Superfund Record of Decision:

South Valley (PL-83), NM

DECLARATION FOR THE RECORD OF DECISION

FORMER AIR FORCE PLANT 83/GENERAL ELECTRIC
SOUTH VALLEY SUPERFUND SITE
COMMUNITY RELATIONS RESPONSIVENESS SUMMARY

FIGURE FOUR

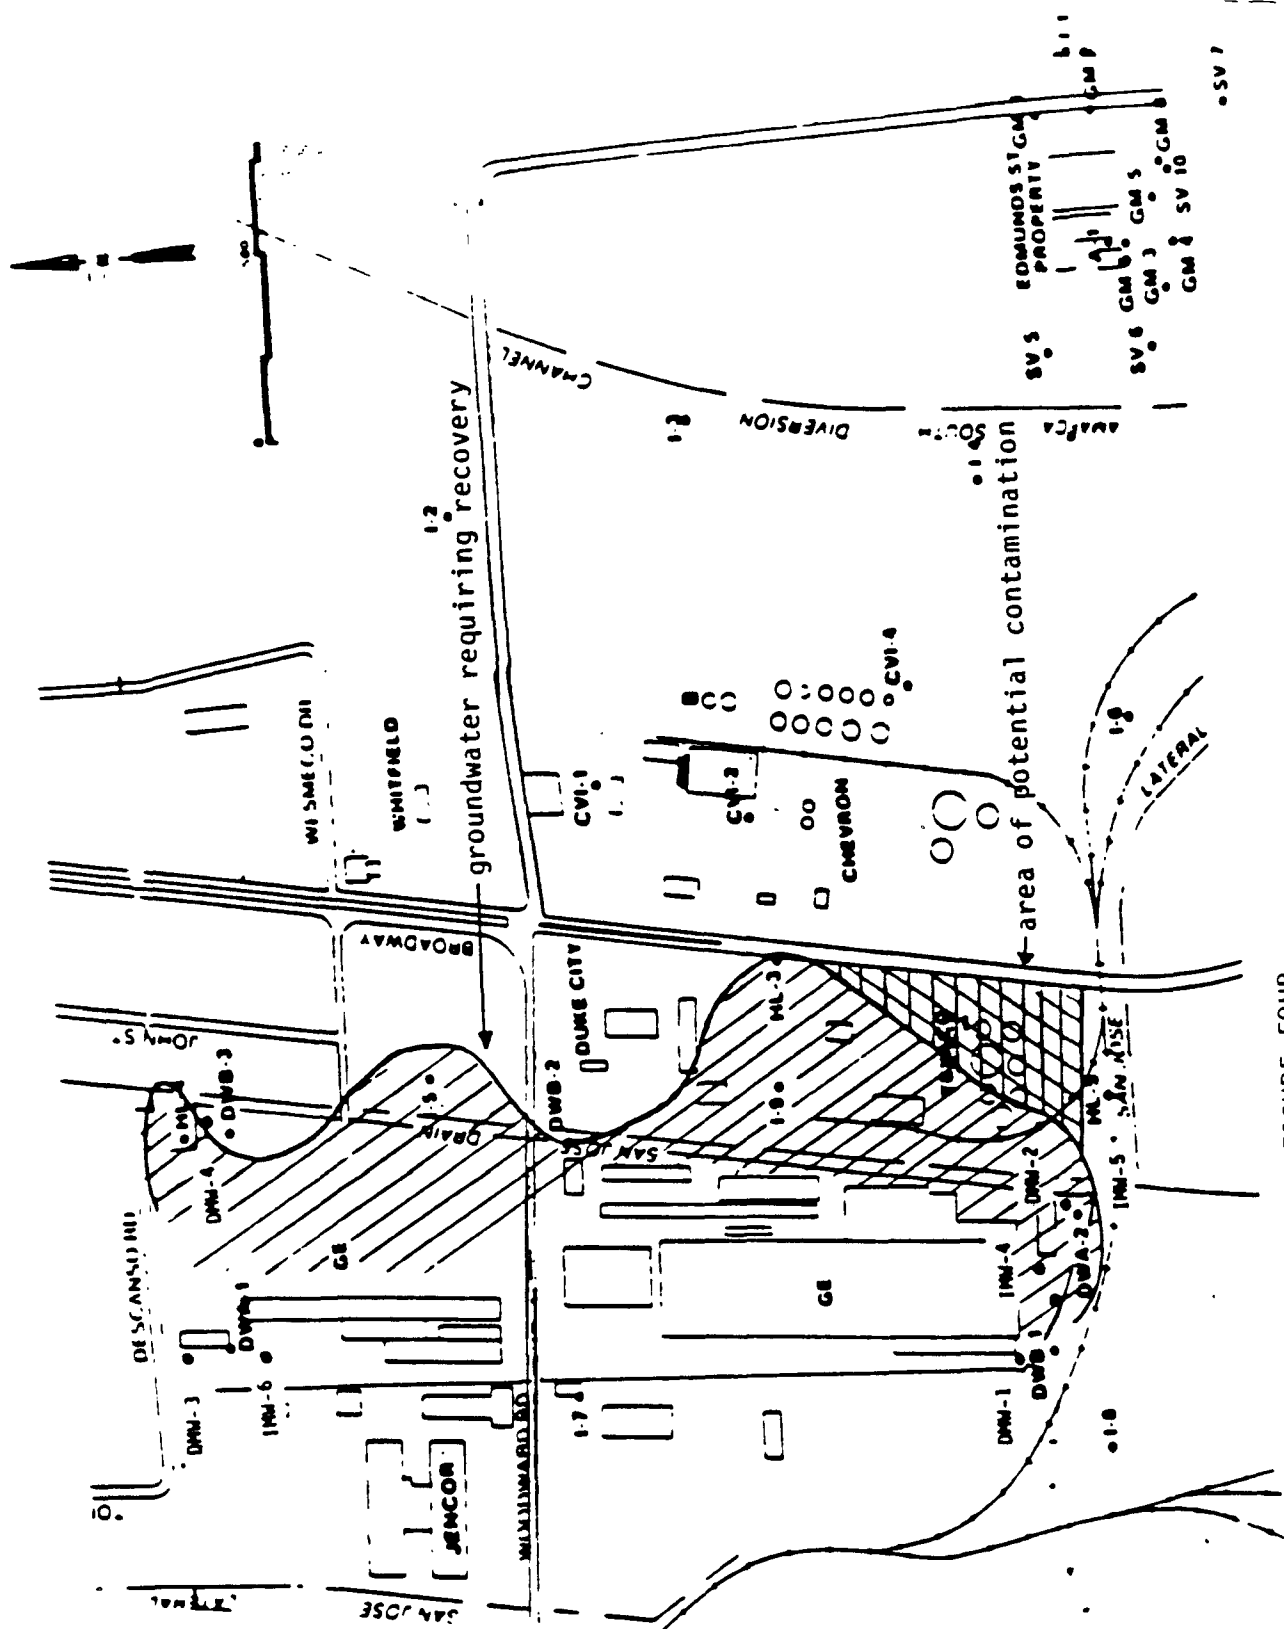
Comment 36: The diagram of contamination in the intermediate groundwater zone [shown as part of the public meeting] does not reach SJ-6.

Response: No it does not. The diagram represents conditions in 1987 and 1988 not those from the period when SJ-6 was in use.
